PLANNING AND ZONING CASE CHECKLIST

Project Number SP2019-037
Project Name Ridge Road Retail Center
Type SITE PLAN
Subtype
Status P&Z HEARING

| Type of Review / Notes | Contact | Sent | Due | Received | Elapsed Status | Remarks |
|--|---------|------|-----|----------|----------------|---------|
| SP2019-037; Site Plan for Ridge Road Retail Center (PD-32) | | | | | | |

| Type of Review / Notes | Contact | Sent | Due | Received | Elapsed Status | Remarks |
|--|---------|------|-----|----------|----------------|---------|
| SP2019-037; Revised Submittal-- Site Plan for Ridge Road Retail Center(PD-32) | | | | | | |

SITE PLAN

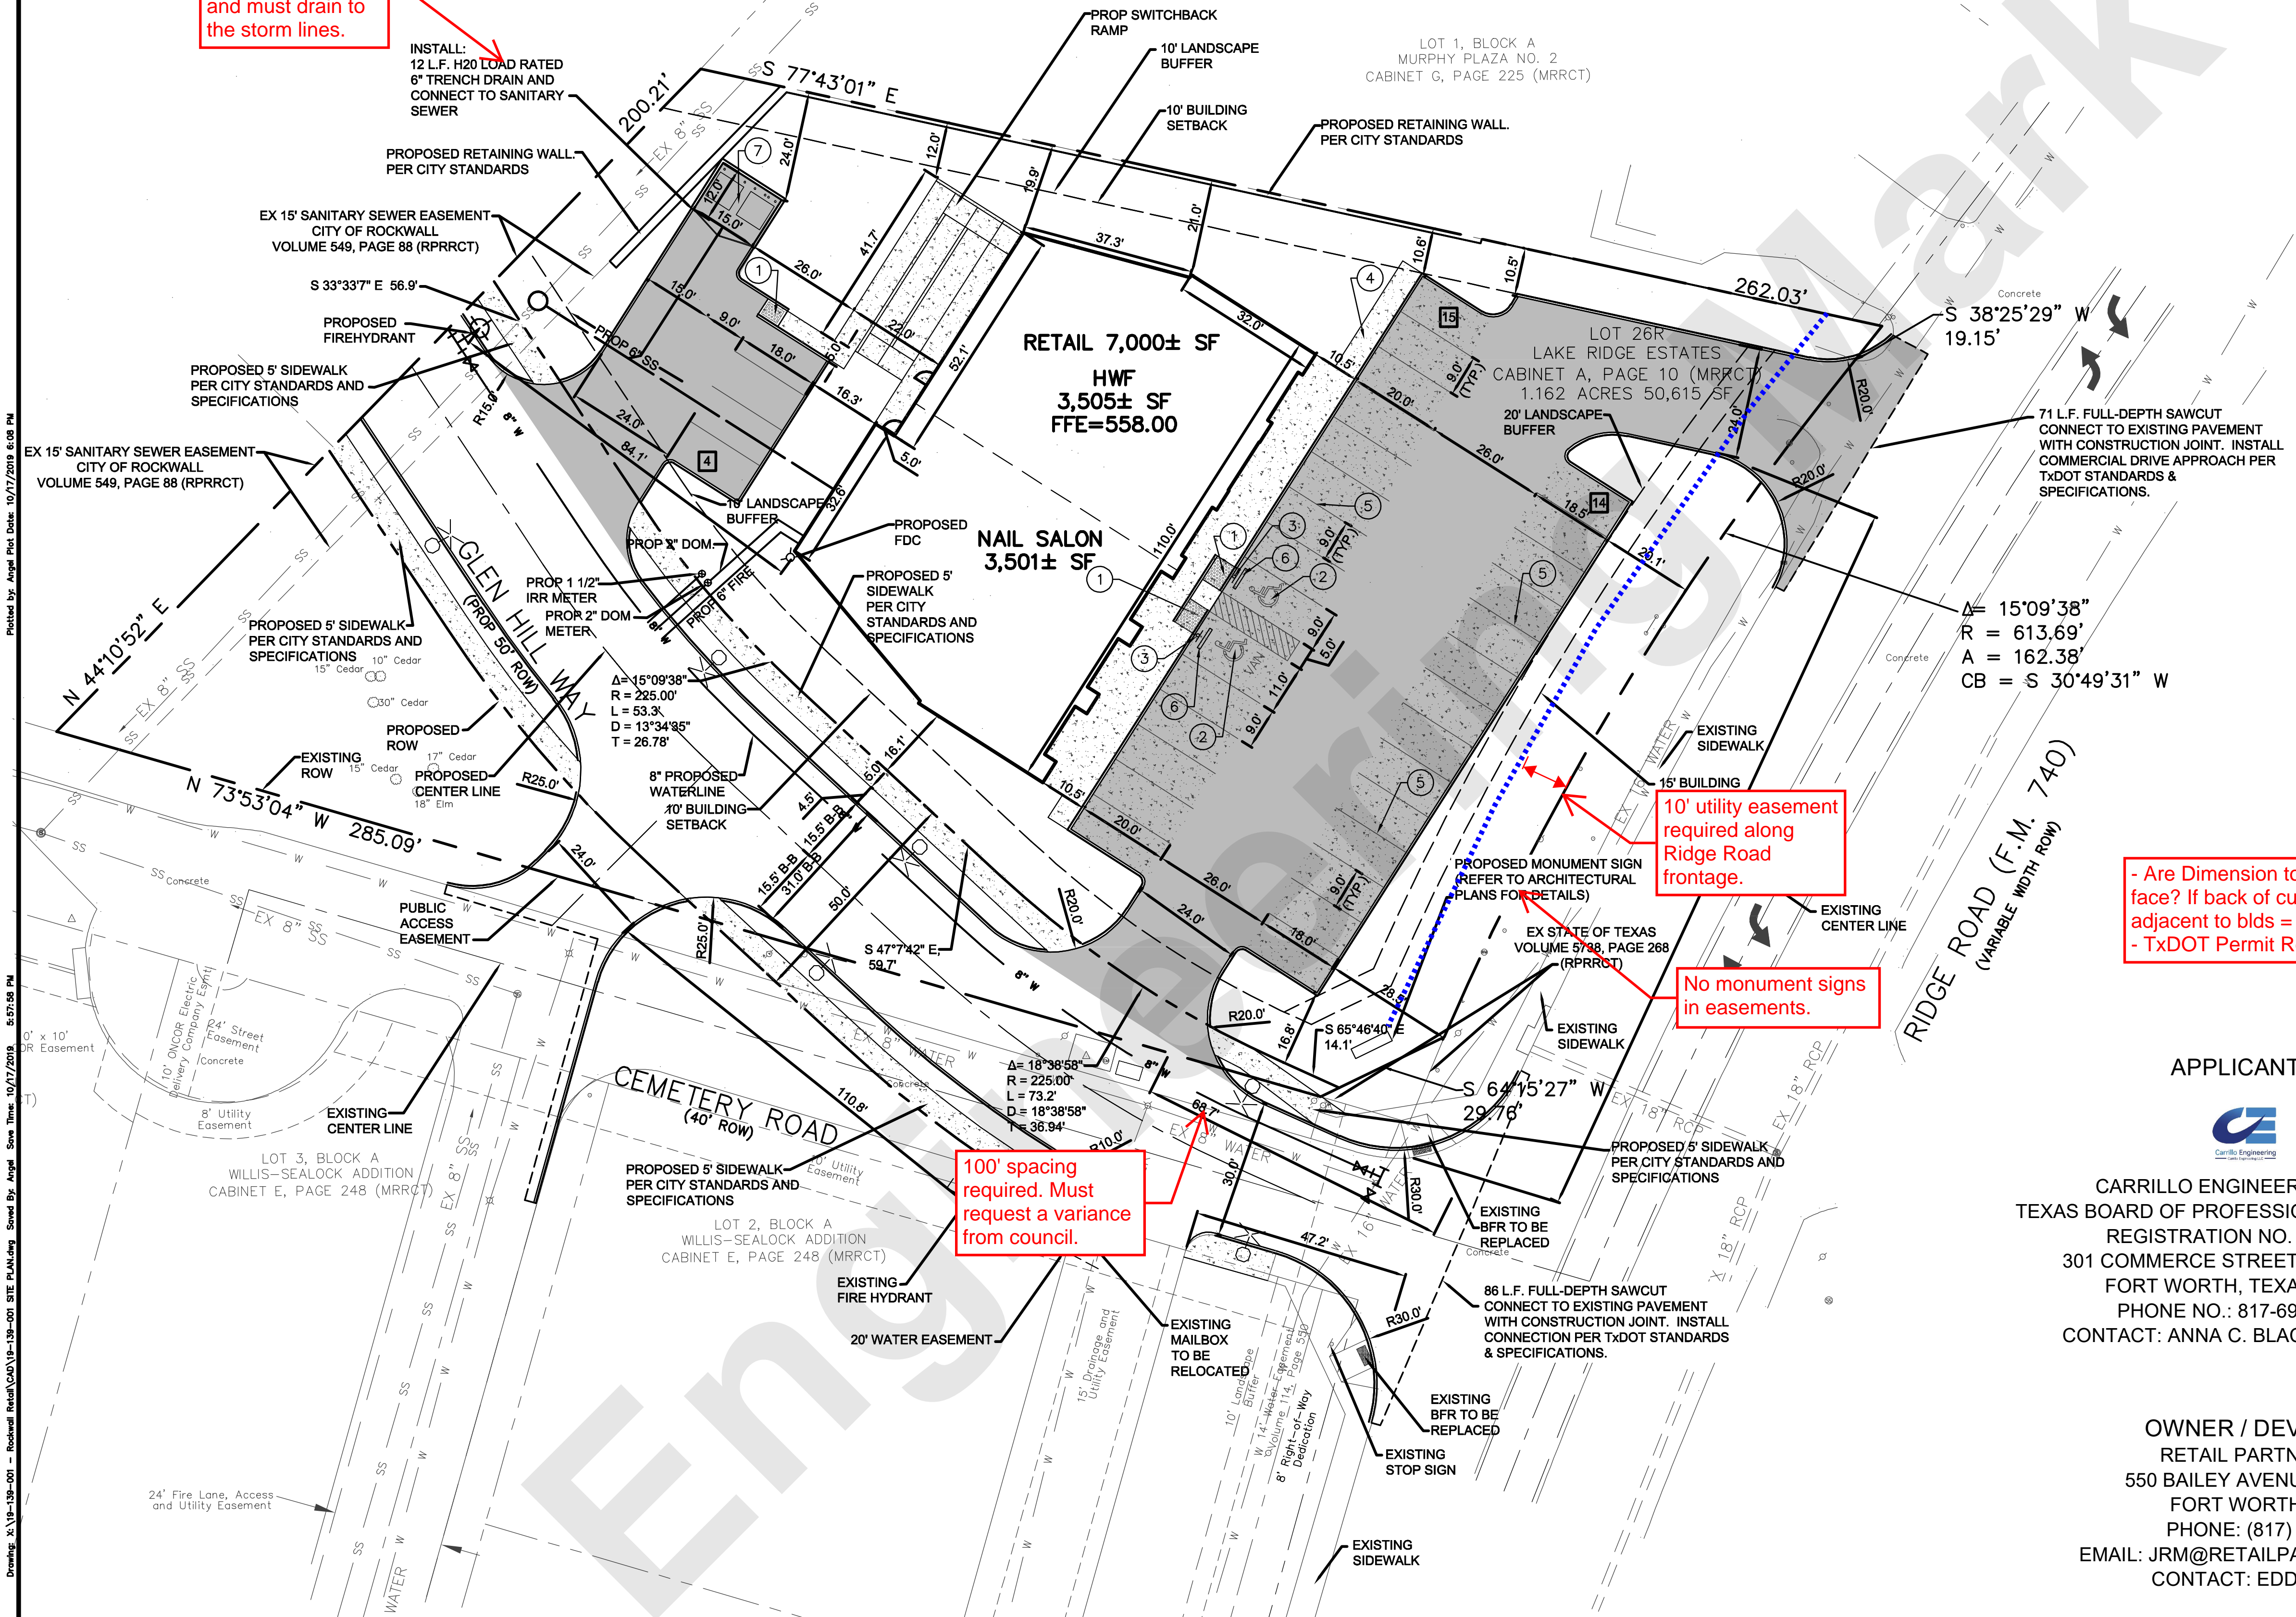
Must have an oil/water separator and must drain to the storm lines.

INSTALL 12 L.F. H20 LOAD RATED 6" TRENCH DRAIN AND CONNECT TO SANITARY SEWER

A3.0

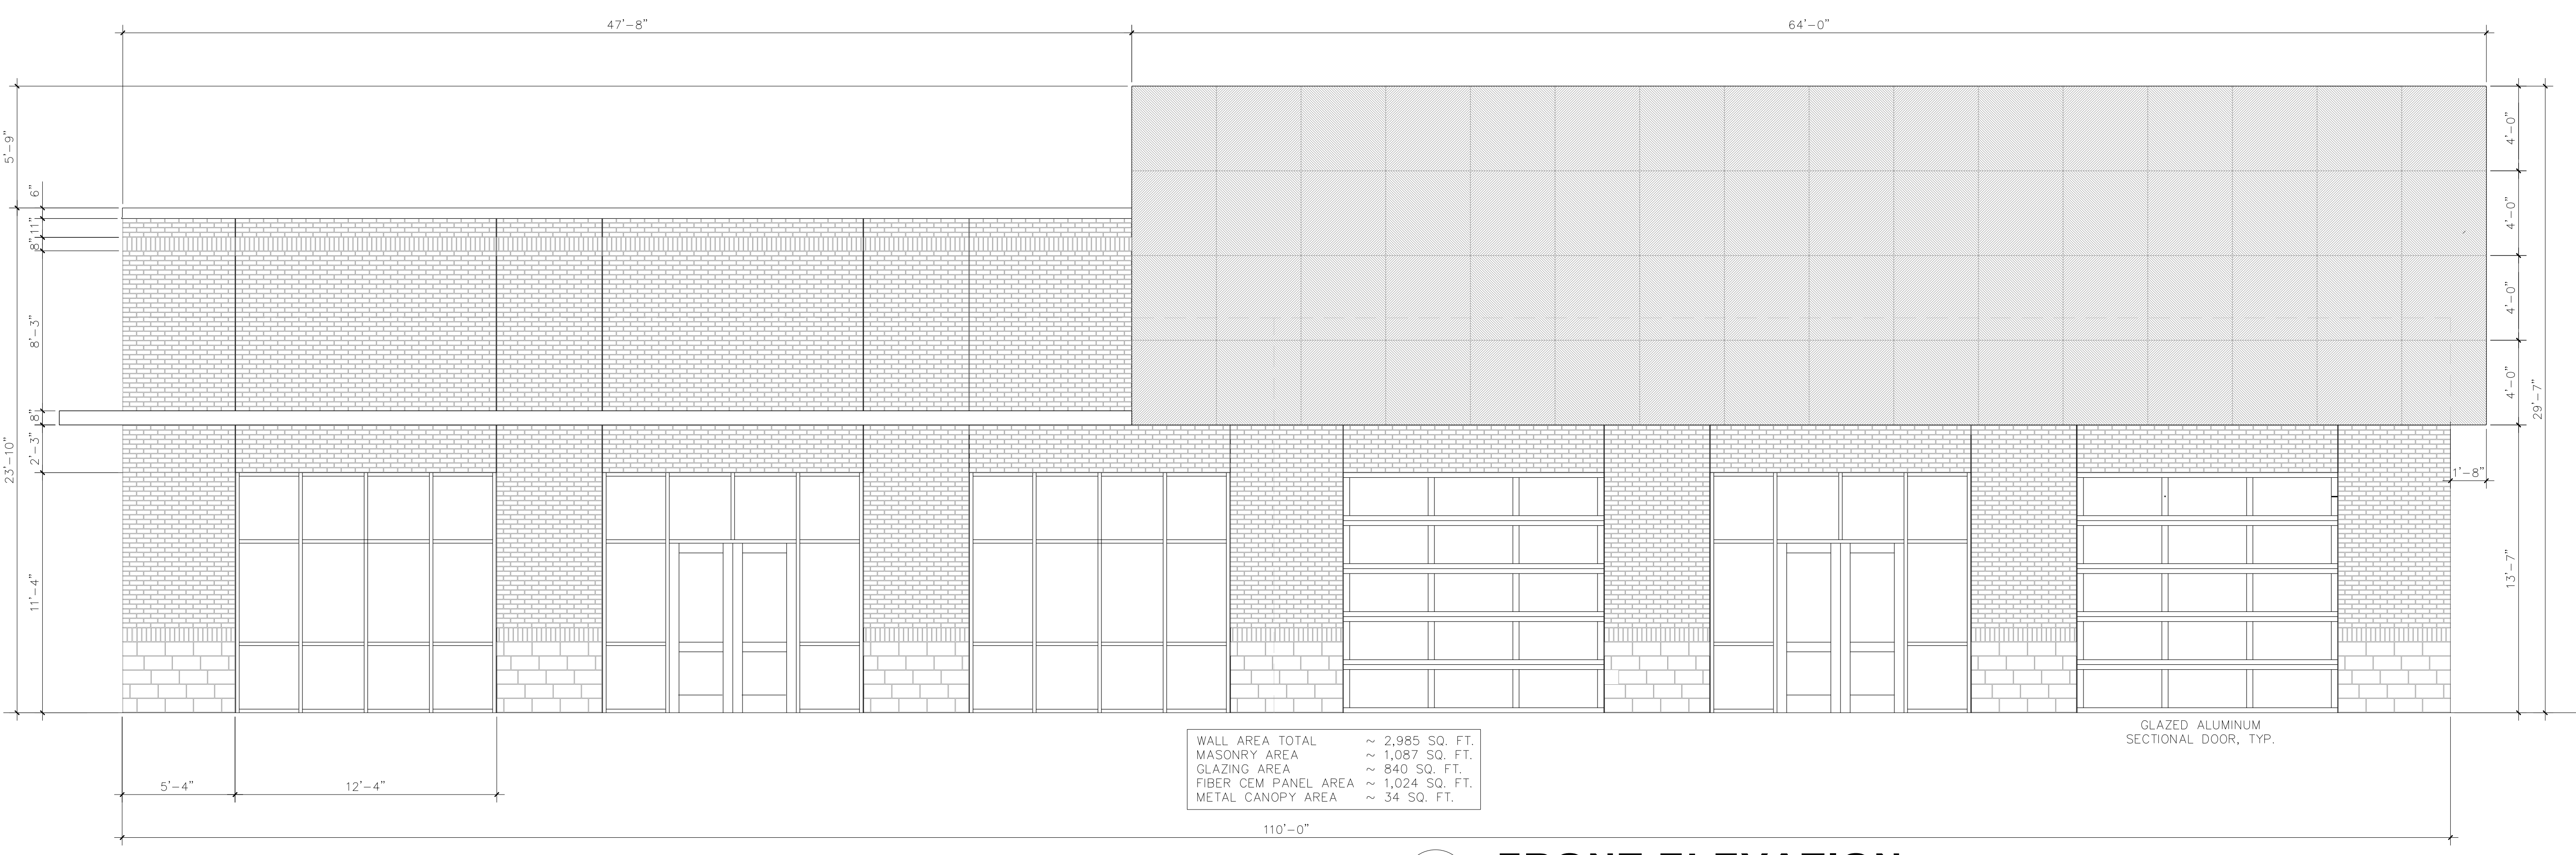
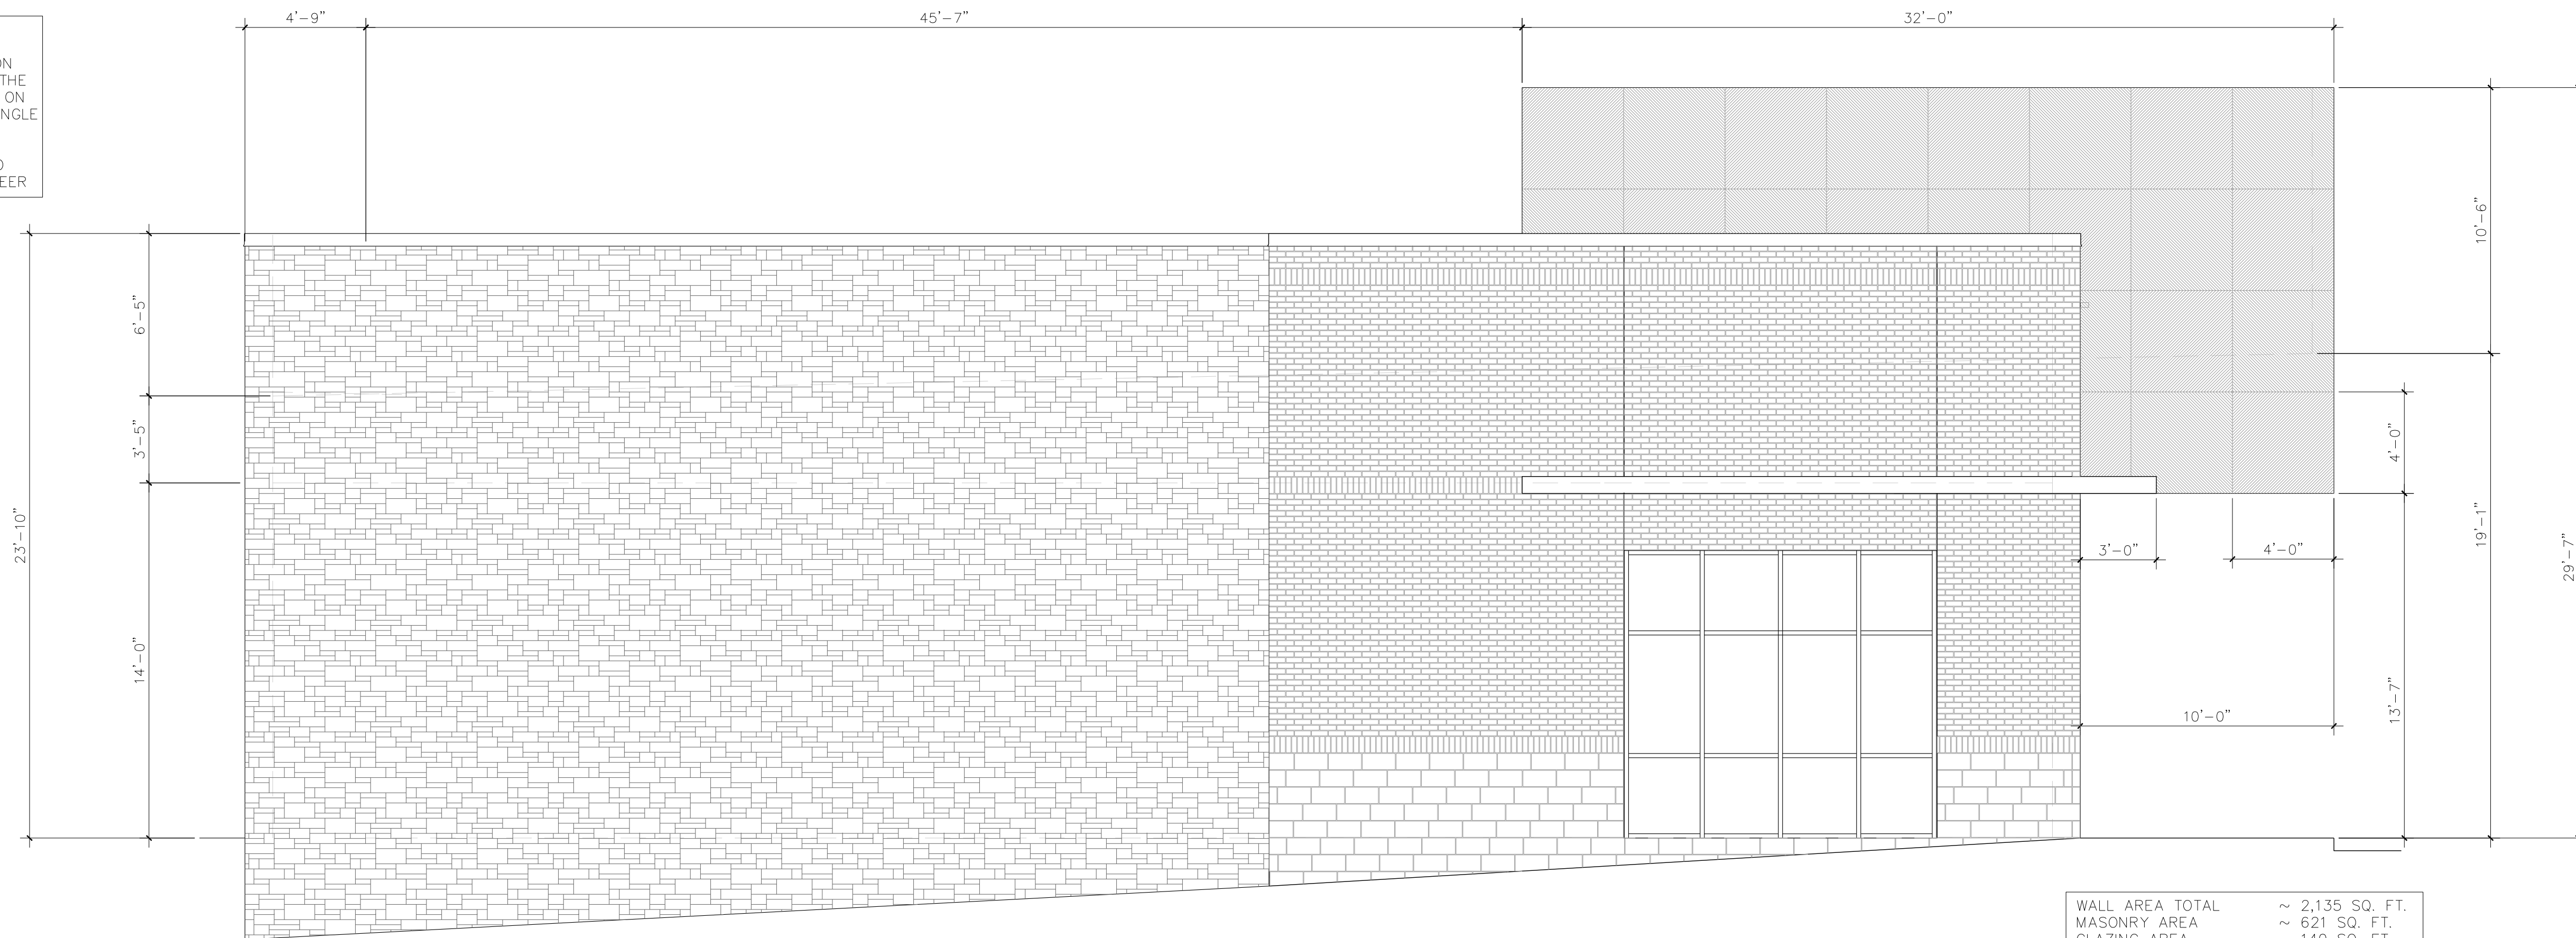
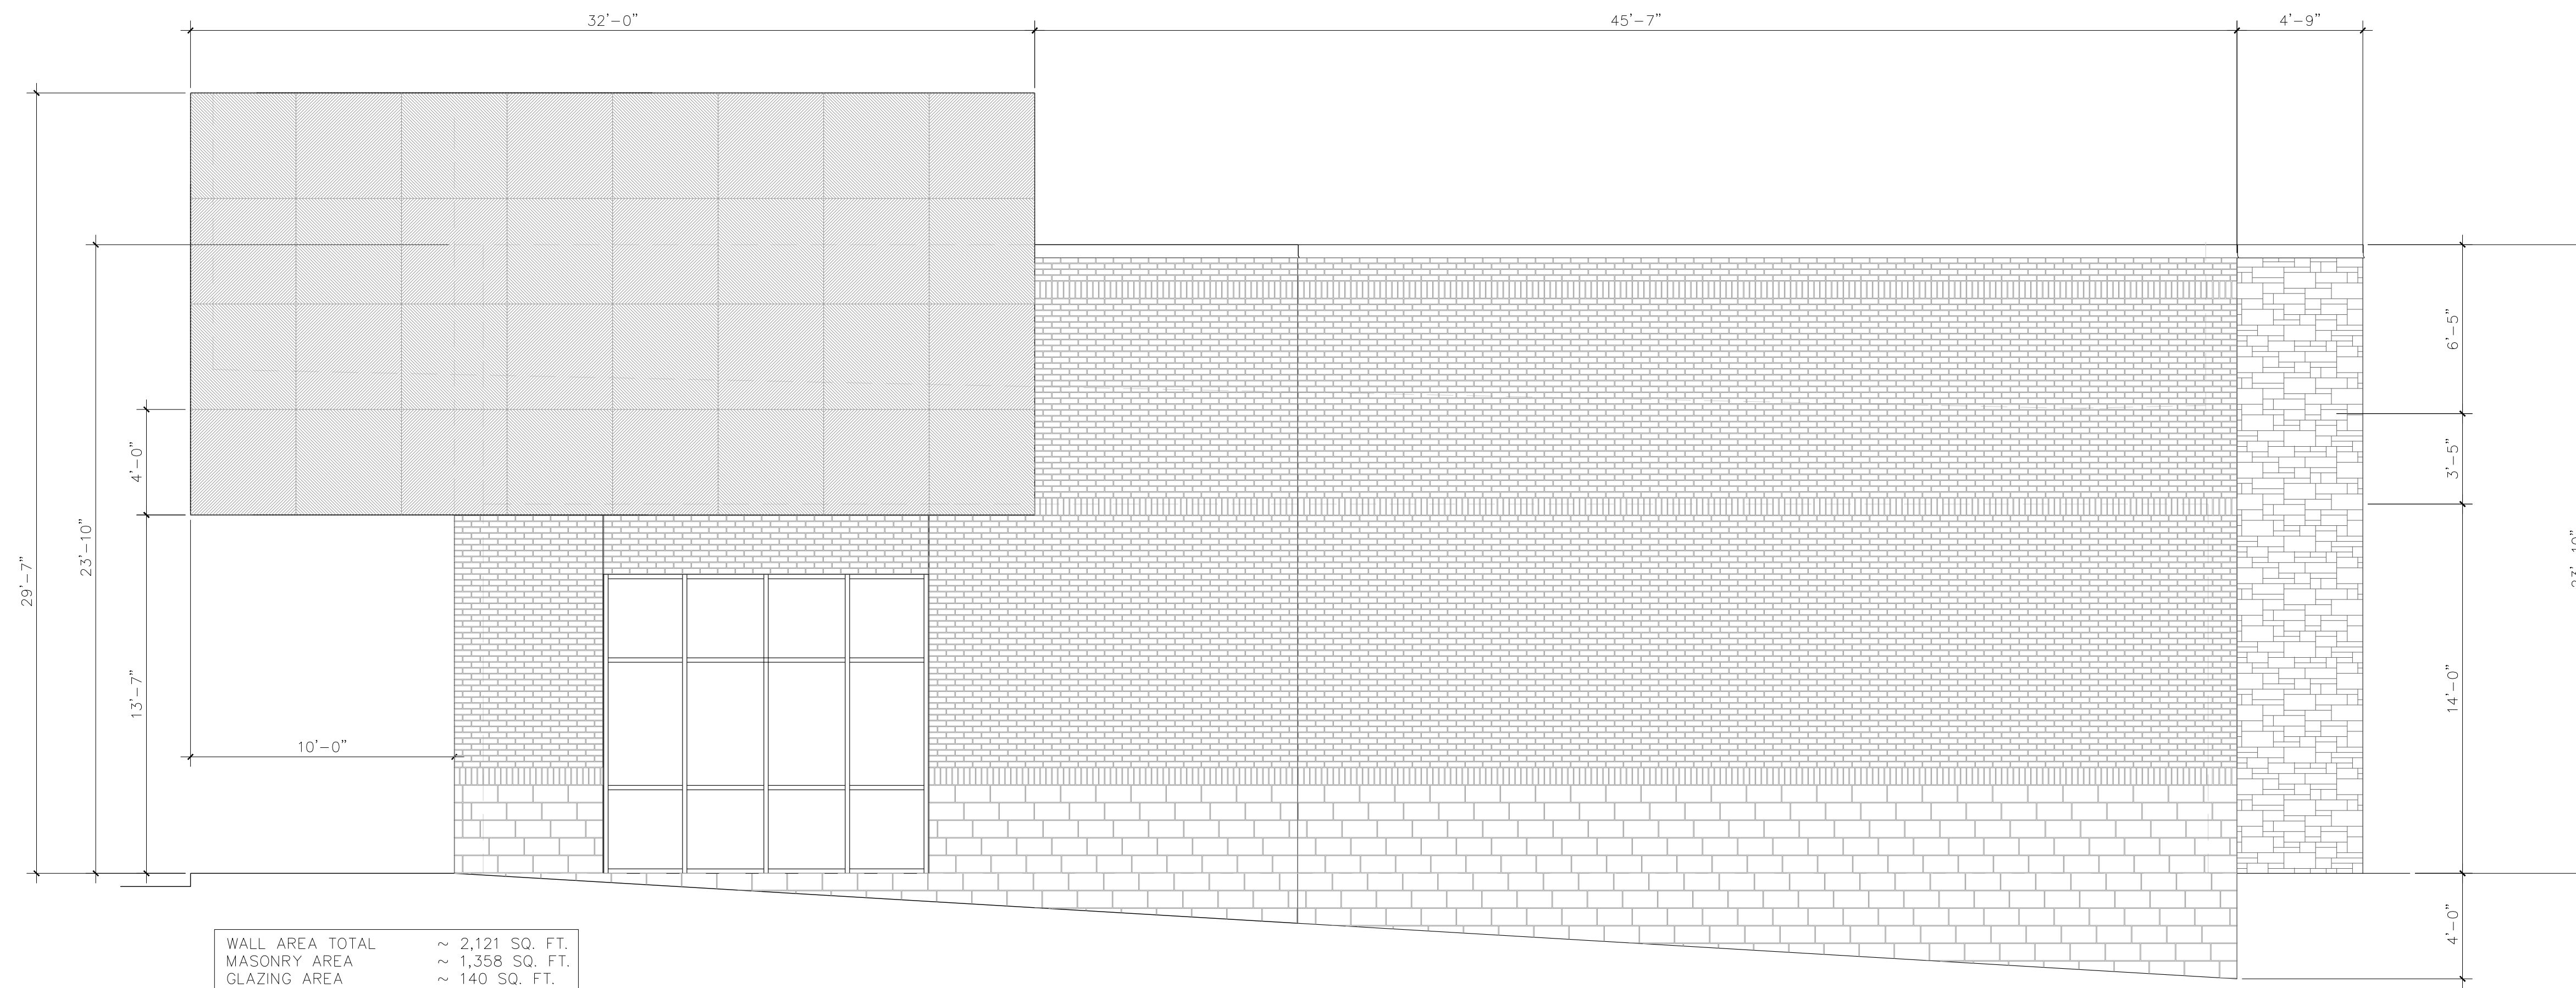
| Type of Review / Notes | Contact | Sent | Due | Received | Elapsed Status | Remarks |
|--|---------|------|-----|----------|----------------|---------|
| M.9 Building Elevations. According to Section 6.2, General Overlay District Standards, of Article V, District Development Standards, of the UDC, each exterior wall of a building's façade shall consist of a minimum of 20% natural or quarried stone. In this case, the revised building elevations do not incorporate stone on the front (east) and side (south) facing facades. This will require a variance from the Planning and Zoning Commission pending a recommendation from the Architectural Review Board (ARB). | | | | | | |
| 2) Please provide a detail for the parapet height to determine screening of RTUs. | | | | | | |

| Type of Review / Notes | Contact | Sent | Due | Received | Elapsed Status | Remarks |
|--|----------------|------------|------------|-----------|----------------|------------------------|
| 3) Please provide a label for each building elevation's facing direction (i.e. north, south, east, west). 4) Provide calculation of building materials as a percentage | | | | | | |
